Re: Feedback on 2026 RTEP Assumptions (as presented at the April 7, 2026, TEAC)

Comments of FirstEnergy to PJM Planning Staff on 2026 RTEP 8-Year Capacity Expansion Assumptions

Maryland DNR Power Plant Research Program Response to 2026 RTEP Assumptions

Figure 4: 2024 – 2033 ELCC Class Ratings for 4-hr Storage, 6-hr Storage, Solar Hybrid Open Loop (OL) - Storage Component, Solar Hybrid Closed Loop (CL) - Storage Component

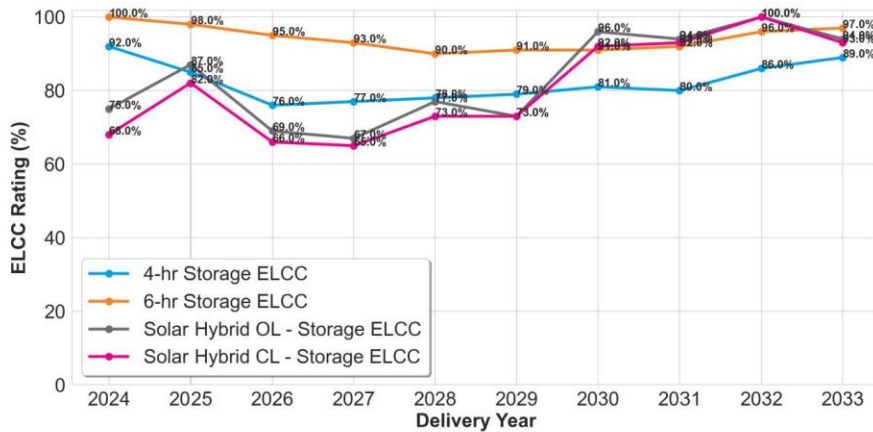
- On the ELCC assumptions (presented on slide 48 of the TEAC presentation, attached and shown below):

1. Could you please explain why hybrid solar+storage resources will only receive half of the ELCC of a battery plus the full ELCC of a solar resource. Why shouldn't the hybrid resource receive the full ELCC credit of a battery? How does the team reconcile this assumption with PJM's 2023 ELCC report, which calculates hybrid solar+storage resources achieving ELCC values between 0.65 and 1 and, especially, increasing over time? See excerpt from PJM's 2023 ELCC report below:

Figure 5: National average capacity credits vs. generation shares across technologies. The x-axes are the ratios of solar PV generation, onshore wind, and offshore wind over total system generation, and ratios of 4-hour and 8-hour battery capacities over total system capacity.

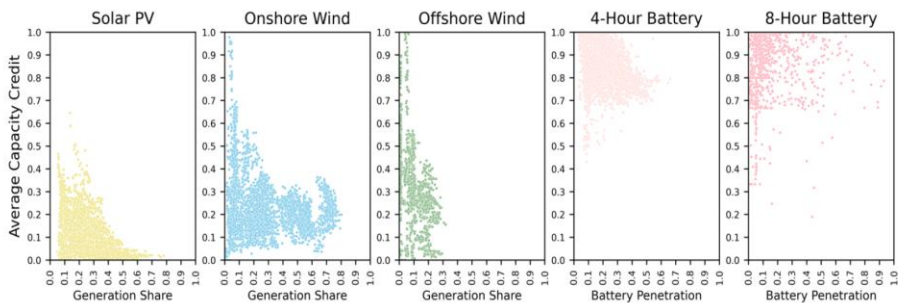
- Could you please explain why the ELCC of a battery declines with increasing penetration? Why does PJM assume that battery ELCC declines with greater battery penetration in two of three summer scenarios and all three winter scenarios, when NREL modeling shows that battery ELCC stays fairly high (between 0.7 and 1) over various levels of penetration and various weather scenarios (see attached NREL report)? See excerpt from NREL report below:

KEY TAKEAWAY

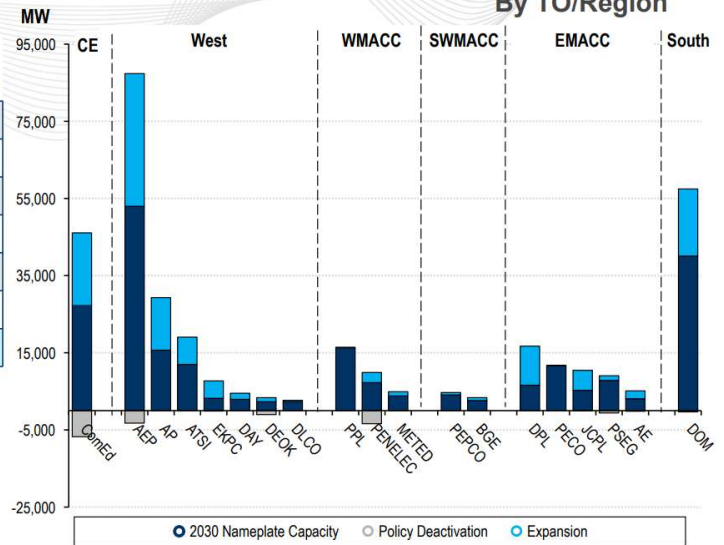
- ComEd and West accounts for 66% (81 GW) of 123 GW of capacity expansion.
- Most of the expansion is forecasted in AEP (34 GW), CE (19 GW), DOM (17 GW), AP (14 GW) and DPL (10 GW).

- Under Scenario A (Base Case for 2034), PJM does not plan to model new gas generation in NJ, MD, DE, and IL, aligning with those states’ clean energy mandates. However, it is unclear why PJM also excludes new gas in eastern Pennsylvania. Unlike NJ and MD, Pennsylvania has not enacted a “Carbon Free” mandate prohibiting gas expansion. In fact, Pennsylvania’s policies and tax incentives for energy infrastructure indicate continued support for gas as a transitional resource. Over the past decade, eastern Pennsylvania has been one of the focal points of greenfield gas development in PJM. In particular, the PPL and MetEd zones have seen the highest concentration of new gas builds in PJM’s footprint because they sit directly on the edge of the Marcellus Shale production area. Modeling a “hard stop” to this established trend in the 2026 RTEP deviates from geological and economic realities. Given strong demand growth in eastern PA, including new gas generation in this region will better reflect current state policy and avoids overstating transmission needs. PPL also notes that initial applications in PJM’s Generation Cycle 01 show significant natural gas submissions in the PPL region, further confirming that PJM’s proposed assumptions are inappropriate.
